ADDENDUM NO. 1

City of Rochester
Bid No. 07-66

Hanson Street/Central Avenue Reconstruction
Rochester, New Hampshire

Bench Detail
(Item 670.51)

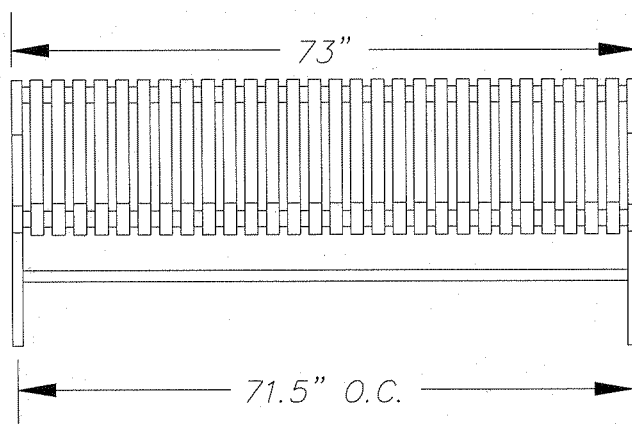
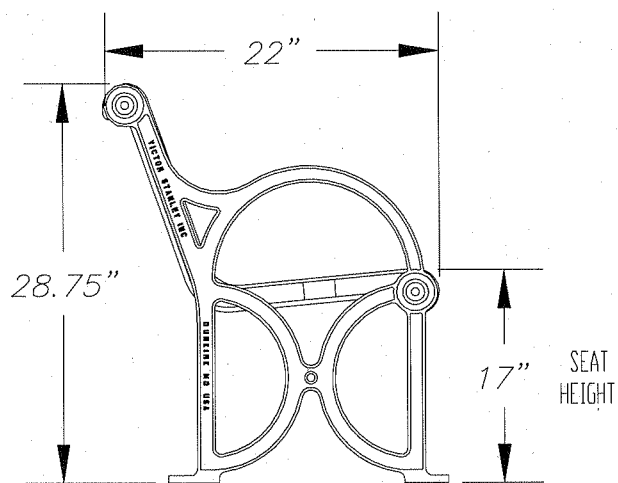
Bidder's attention is directed to the detail for 6-Foot Steel Bench (Item 670.51) attached to this Addendum No. 1. Placement of the benches will be as shown on plan sheet 58 of 78 – Sidewalk Detail and Amenities Layout Plan.

**HANSON STREET
SIDEWALK DETAIL &
AMENITIES LAYOUT PLAN**

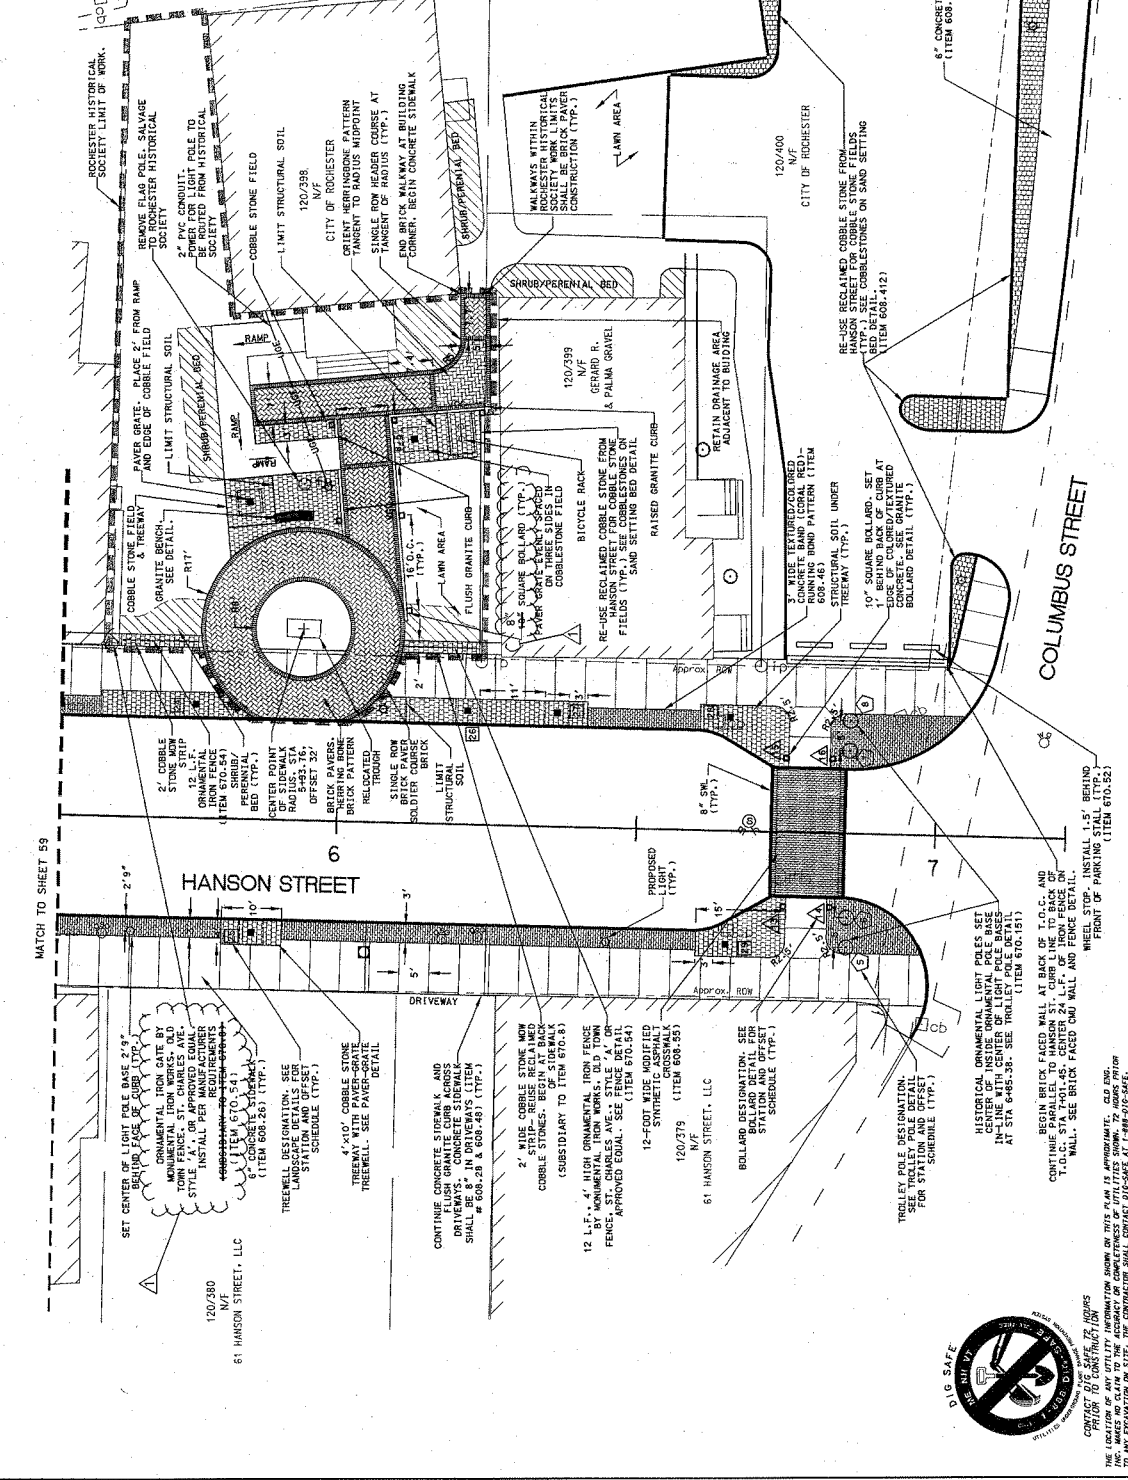
- 10" Square Bollards (Granite) shown on plan sheet 60 of 78 on the Historical Society Site shall be changed to 8" Square Granite Bollards conforming to Item 670.42 - Granite Bollard. As noted in the Special Provision for Item 670.8 - Historical Society Hardscape Improvements, no separate payment will be made for Granite Bollards installed on the Historical Society Site since all work on the site is to be included in the Lump Sum item.
- Brick paver walkways called for within the Historical Society Site shall be New England Classic Concrete Pavers by Bolduc, or approved equal.

Ornamental Iron Fence and Gate as depicted on Plan Sheet 60 of 78 are to be paid under Item 670.54 - Decorative Metal Fence and Gate and will not be subsidiary to Item 670.8 - Historical Society Hardscape Improvements.

The following plan sheets dated May 2007 are to be replaced with the attached plan sheets with Revision #1 noted and dated June 2007 to reflect changes in bollards, sidewalk pavers, and fencing items noted above.

NO.	DATE	REVISION
16/07		CHANGE PAV. ITEM FOR GATE TO ITEM 670.54.
16/07		CHANGE BOLLARD SIZE FROM 10" TO 8".
